# 2024 Dam Safety Review

## HB Tailings Facility

Salmo, BC

MAY 26, 2025  
ISSUED FOR USE (REVISION 01)  
704-ENG.DAMS03004-01

**Figure 6: Water Level Fluctuations in Standpipe Piezometers (July 2022 – June 2024)**

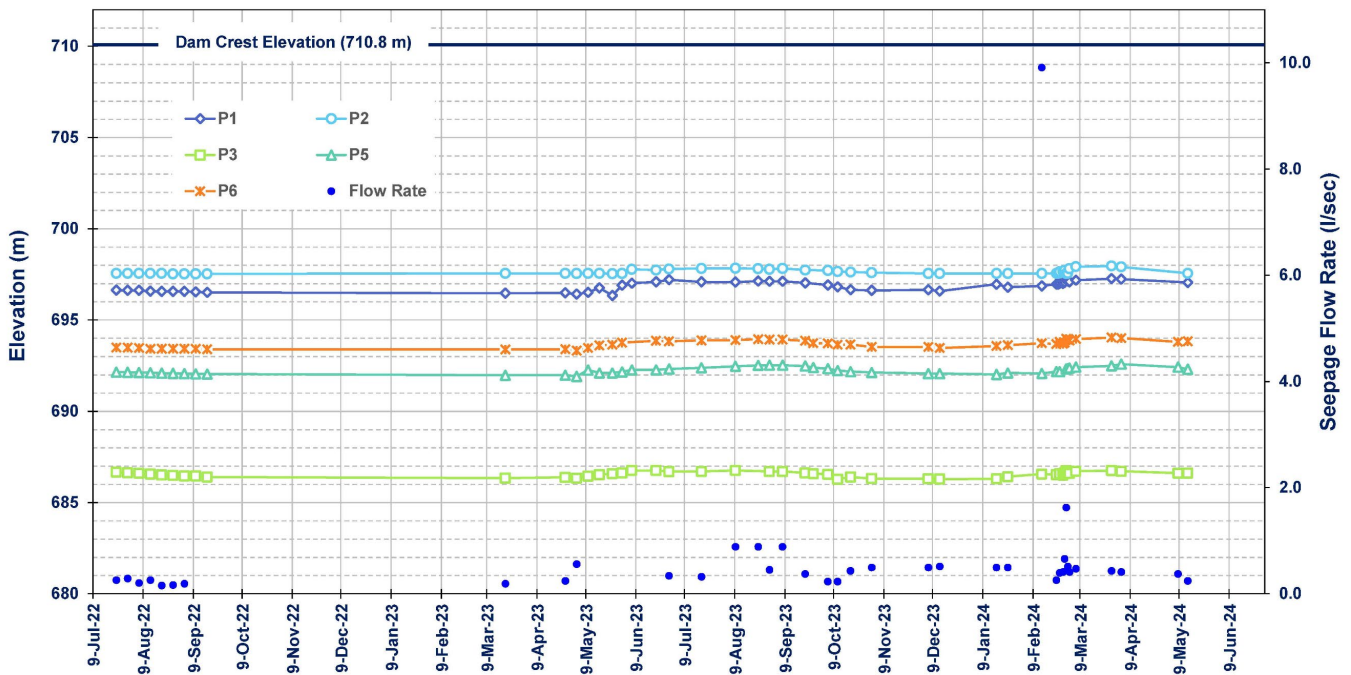
Monitoring data collected from the standpipe piezometers and seepage weir over the past two years (July 2022 to June 2024) are presented in Figure 6. Based on the data recorded over the past two years, it appears that there is a direct relationship between the piezometric levels, and the flow rates recorded at the seepage weir. During this period, the highest flow rate was recorded on February 14, 2024, due to high precipitation event (53 mm in 24 hours). The water level fluctuations of piezometers together with the trigger level for each piezometer during the past two years are also provided in Appendix G, Figures E.1 to E.5. Based on the historical piezometric data during this period, Piezometer P1 was the only one to exceed its trigger level of 697.2 m in late July 2023, as well as in late March and early April 2024.

**Figure 7: Movements Recorded in Survey Hub Monitoring Points (2021-2022)**

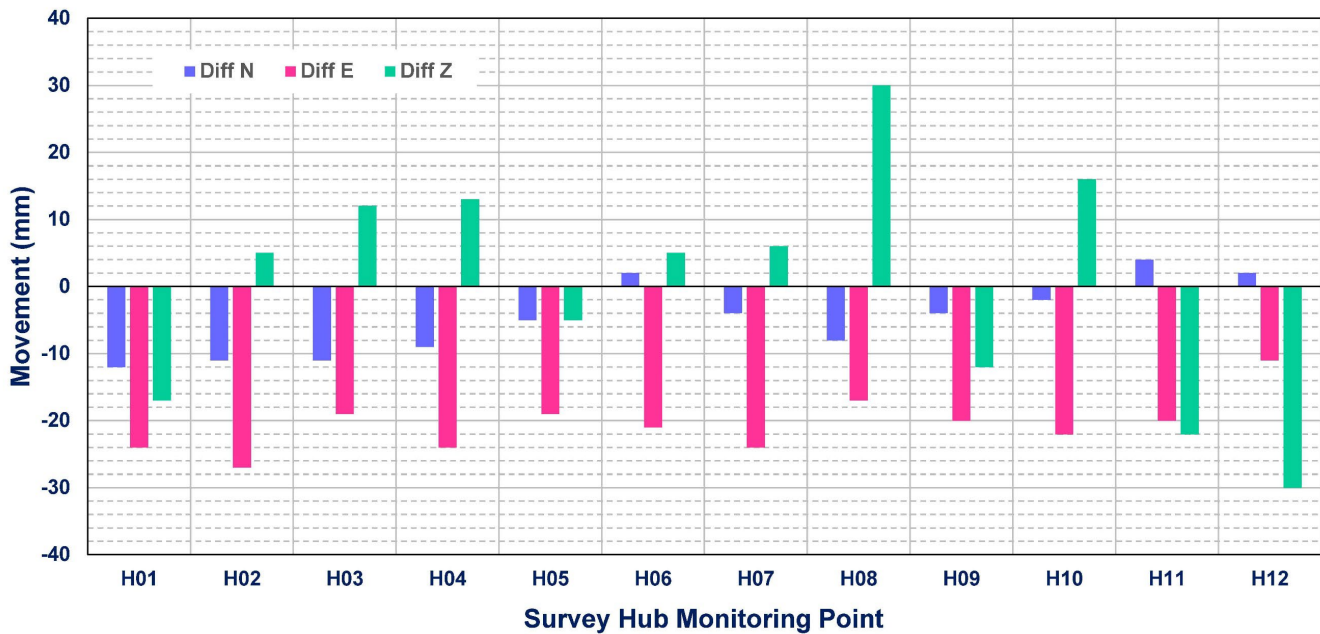
The movements of the survey hub monitoring points were measured in 2021 and 2022, and the results were reported in the 2023 annual DSI (SRK, 2024). The recorded data is graphically presented in Figure 7. According to SRK (2024), movements within  $\pm 100$  mm are considered normal. The highest movements were observed at survey hub H08 (+30 mm in the vertical direction) and H12 (-30 mm in the vertical direction). Figure A.4 in Appendix A illustrates the location of the survey hub monitoring points.

**Photo D.6: View of downstream slope face of the dam and the crest of expanded toe berm, looking from the dam crest to east. The downstream slope of the dam appears to be in general good condition.**

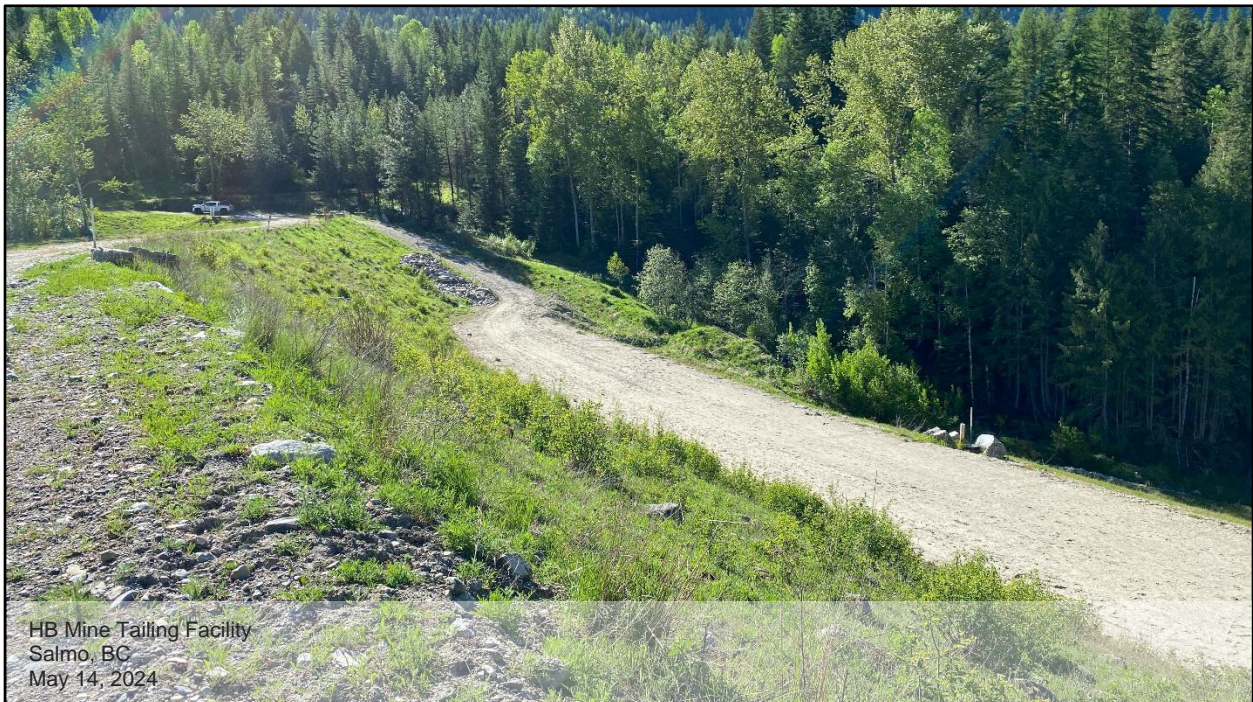
Well established vegetation was observed throughout the downstream slope face above the toe berm. Tetra Tech understands that the west side of the downstream slope was repaired in 2012, and a layer of riprap has been placed over this area. It is also understood from RDCK that a vegetation removal plan is in place to control the vegetation along the downstream side. No sign/evidence of exceeding surface erosion, seepage, or significant instability was noted along the downstream slope of the dam. The downstream slope of the dam appears to be in general satisfactory condition (see Photos D.5 and D.6).

**Photo D.30: Standing Water along with growing algae were found in the east portion of the South Spur Channel, near the SSCED. It apparently occurred due to excess vegetation within the eastern portion of the channel.**

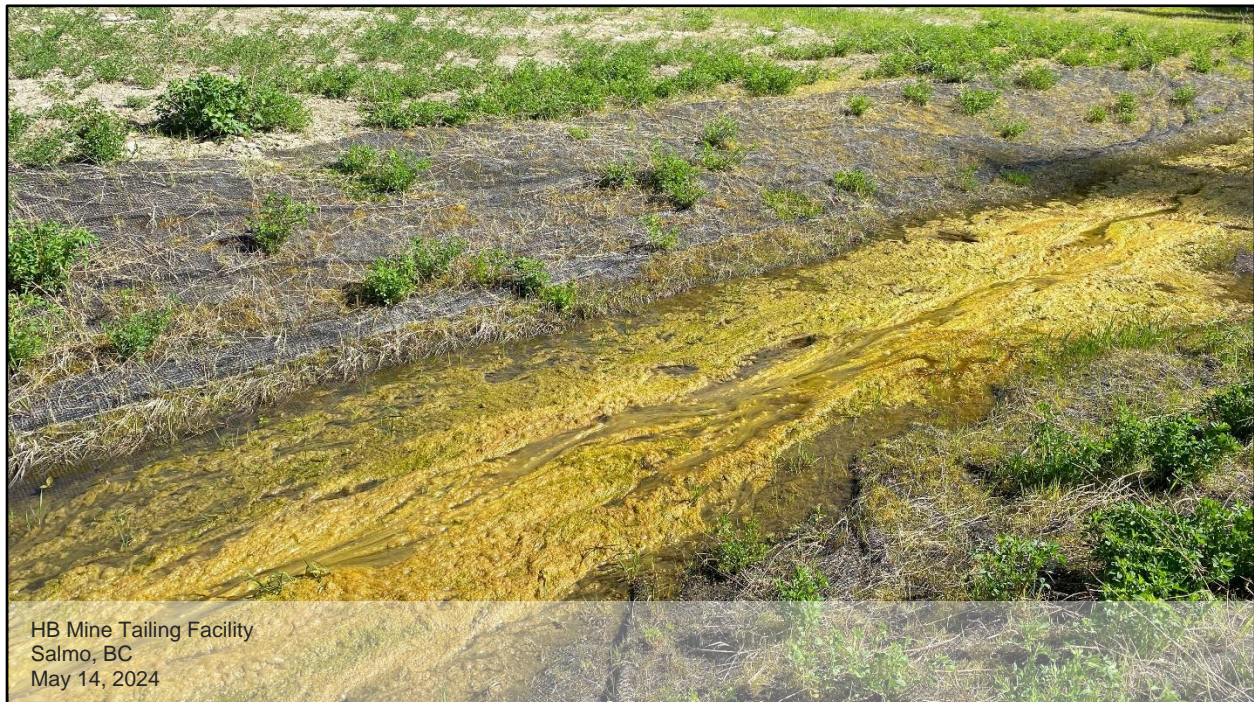
Grassy vegetation is growing along most areas of the channels (see Photos D.25, D.30, and D.33). It is understood that the flow estimates in the hydraulic model for the channels were based on the assumption of grassy vegetation lining the channels; however, the excessive vegetation can obstruct water flow, and the overtopped water flow in turn can cause surface erosion in the tailings cover. Therefore, it is required to be regularly monitored and controlled as part of a regular vegetation removal plan. It is noticed that there are several groundwater monitoring wells installed in the tailings impoundment area. More details about the monitoring wells are provided in subsection 5.4.
